From: [Yu, Olivia, EMNRD](#)
To: Alan.Brandon@ghd.com; [Naranjo, Mark](#)
Cc: [Ericson, Dean](#); Bernard.Bockisch@ghd.com; cctofiling@croworld.com
Subject: RE: Status update for 1RP-4524 (Trunk MC-16) ~COR-11135250~
Date: Monday, April 2, 2018 8:11:00 AM
Attachments: approved_deferral_1RP4524_11135250-4Ericson-Remediation Rpt-Trunk MC 16.pdf

ETC FIELD SERVICES
LEA COUNTY, NEW MEXICO
TRUNK MC-16"

FIGURE 2

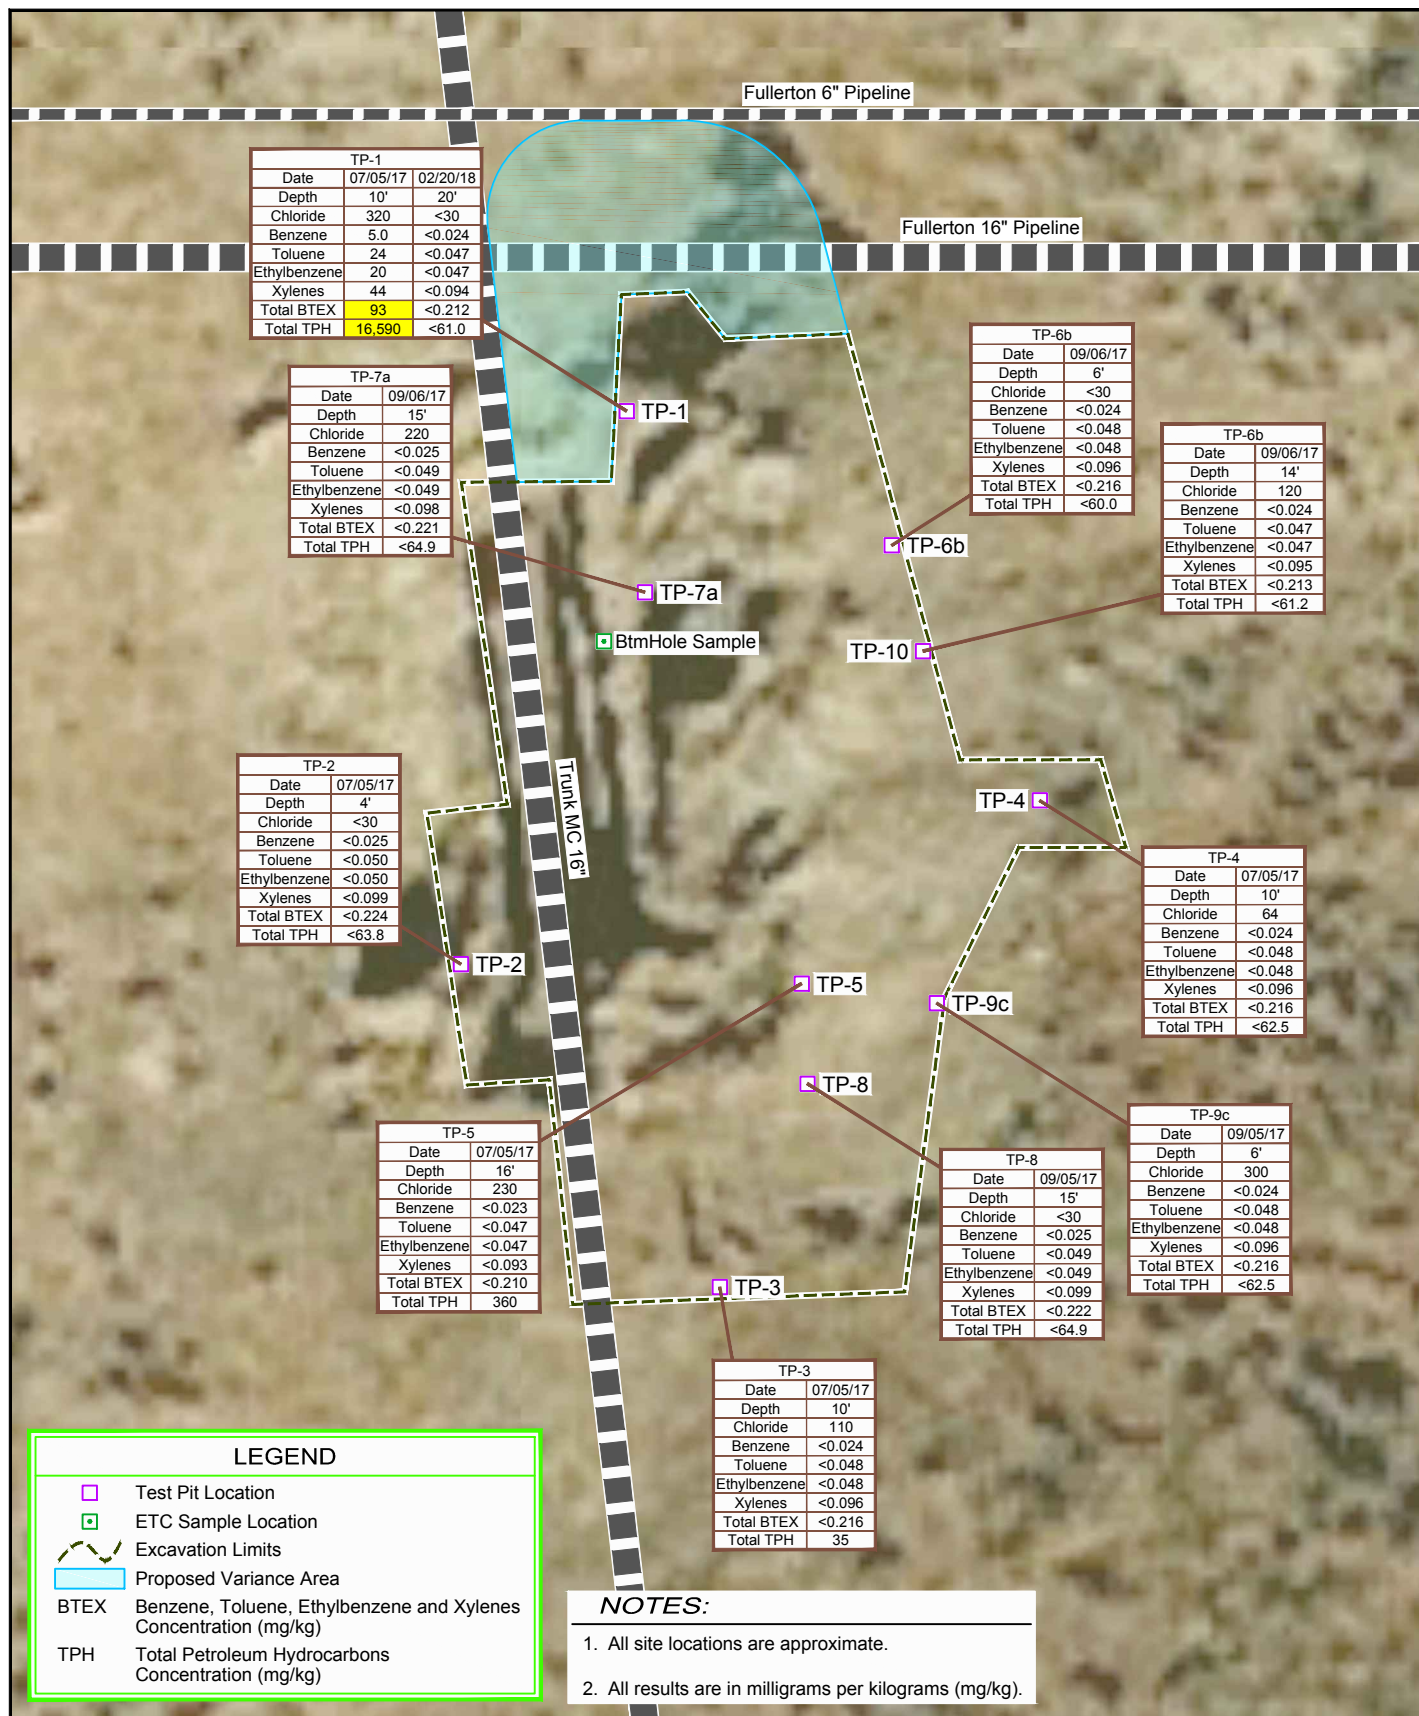
NMOCD will grant deferral of remedial activities to the area between Fullerton 6" and Fullerton 16" pipelines, represented in Figure 2, for 1RP-4524 on the condition that complete vertical delineation of BTEX and TPH at TP-1 occur. What is the radius around the pipelines for deferral?

1. Where was the location of the Btmhol sample?
2. What is the depth of excavation and dimensions of the excavated area?
3. Are the sample depths indicated in Table 1, the depths of delineation trenches or excavation at the sample locations?
4. Were sidewall confirmation samples taken?
5. What is the distance proposed for deferral around the pipelines for delineation and/or remediation?
6. Please demarcate on an appropriately scaled map: 1) the paths of the Trunk MC-16, Fullerton 6-inch, and Fullerton 16-inch pipelines; 2) proposed area for variance; 3) depth of excavation or depths if different; and 4) locations and GPS coordinates of confirmatory sidewall and bottom samples.

Thank you for the additional data and map, regarding the deferral area, for 1RP-4524. NMOCD approves of the delineation and remediation completed for 1RP-4524. Backfill approval is granted for the excavated area. Please submit photo documentation of the backfilled area.

I have attached an updated drawing showing the vertical delineation at TP-1 that you had asked for. I also attached the laboratory report for the sample collected at 20 feet below ground surface. The area that is shaded in blue is the area for deferral.

1. Where was the location of the Btmhol sample? Added location to updated Figure 2.
2. What is the depth of excavation and dimensions of the excavated area? Depth of excavation ranges from 10 to 16 feet deep. Dimensions of the excavation are denoted on the Figure 2.

4. Were sidewall confirmation samples taken? TP-1, TP-2, TP-3, TP-9c, TP-10, and TP-6b were collected from the sidewalls.
5. What is the distance proposed for deferral around the pipelines for delineation and/or remediation? The area is shaded blue on the updated Figure 2.

6. Please demarcate on an appropriately scaled map: 1) the paths of the Trunk MC-16, Fullerton 6-inch, and Fullerton 16-inch pipelines; 2) proposed area for variance; 3) depth of excavation or depths if different; and 4) locations and GPS coordinates of confirmatory sidewall and bottom samples. The pipelines have been added to the updated Figure 2. The excavation
